SUBJECT: Final Water Quality Plan for Gateway Commons – Site Plan # 8-03023

SUBJECT: Site Plan Review #8-03023 – Gateway Commons

SUBJECT: Gateway Commons Subdivision, Plan #8-03023

SUBJECT: Gateway Commons (Site Plan No. 8-03023)

Transit Corridor District Land Use Plan

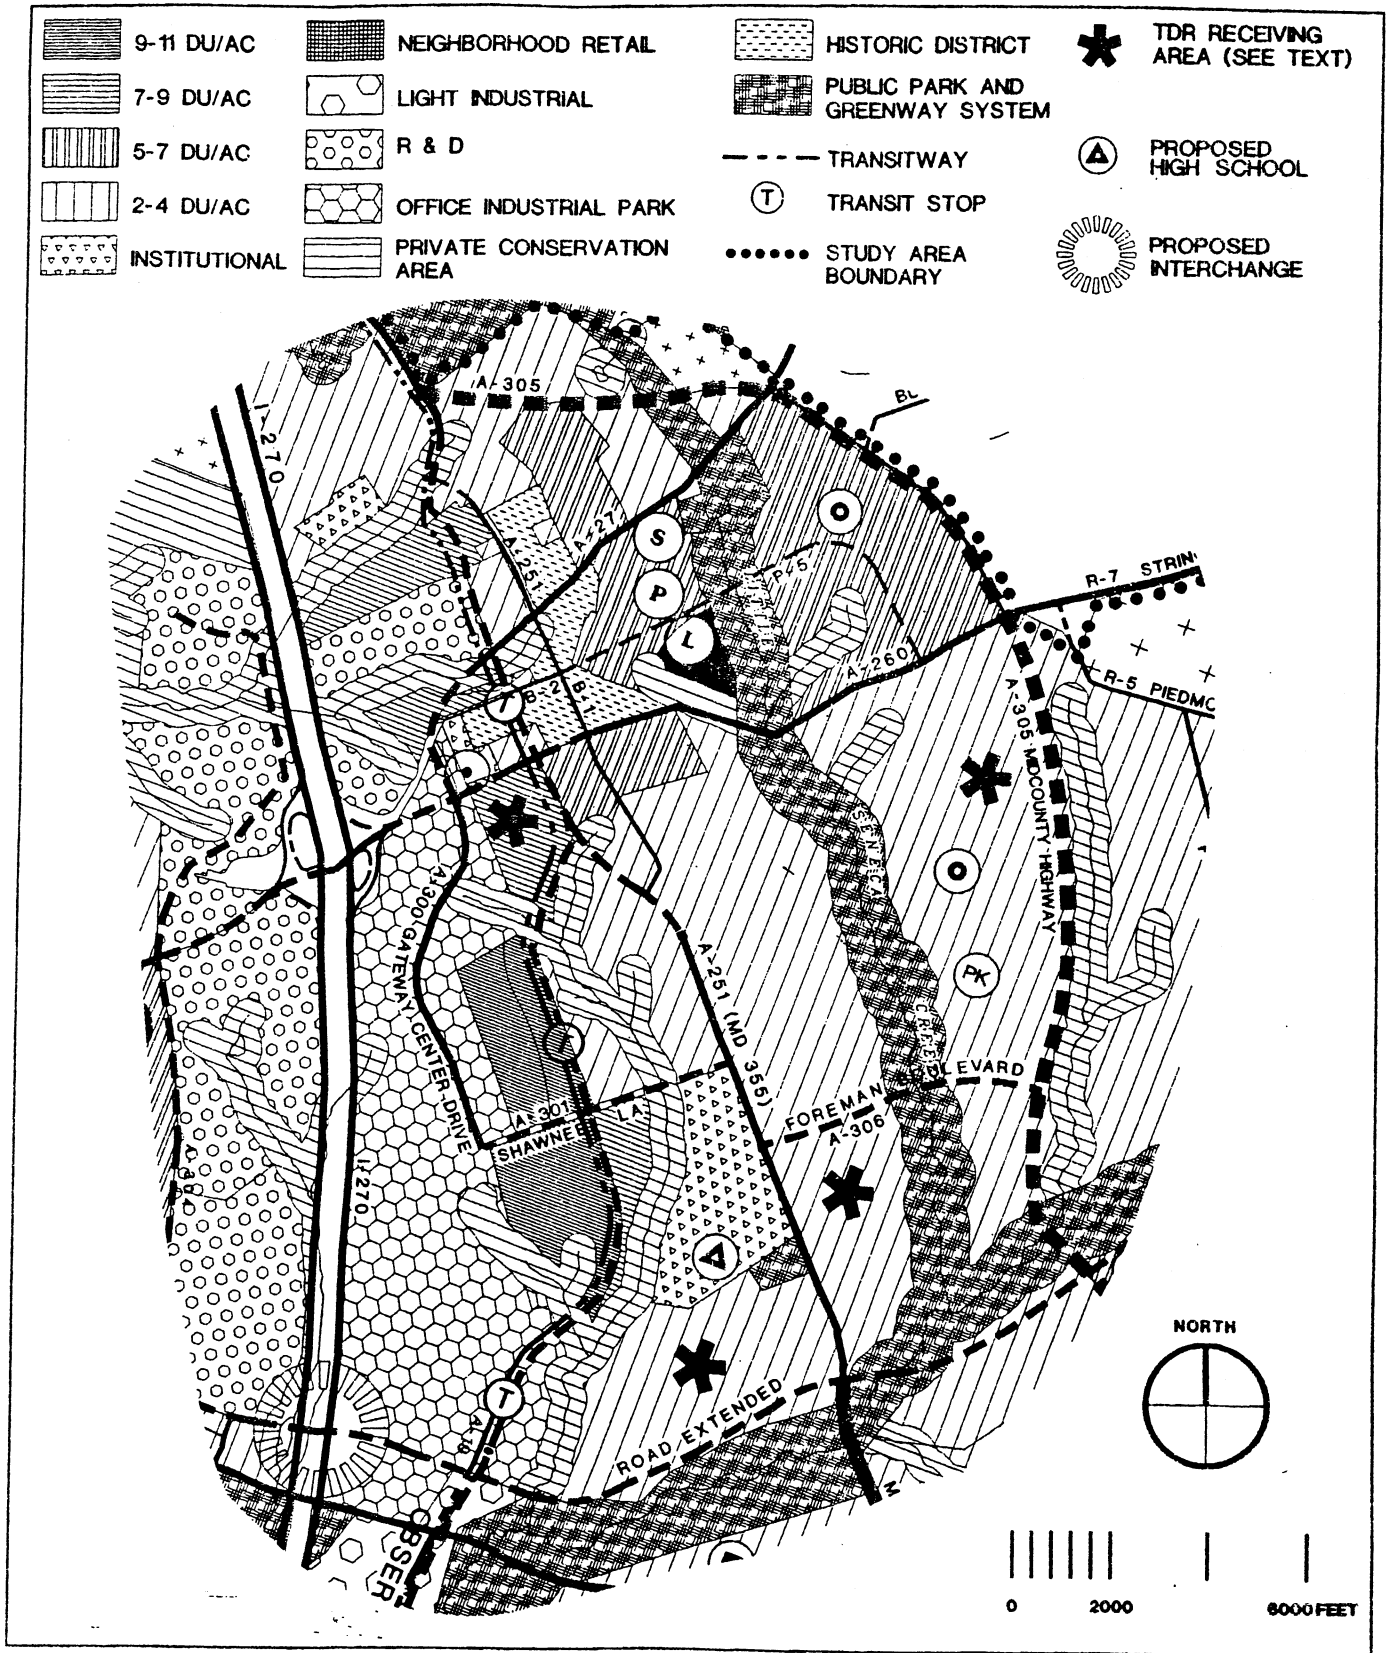
The Master Plan endorses a mix of unit types at the neighborhood level. It avoids large concentrations of any single type of housing within each neighborhood. The proposed site plan conforms to the recommended range of units.
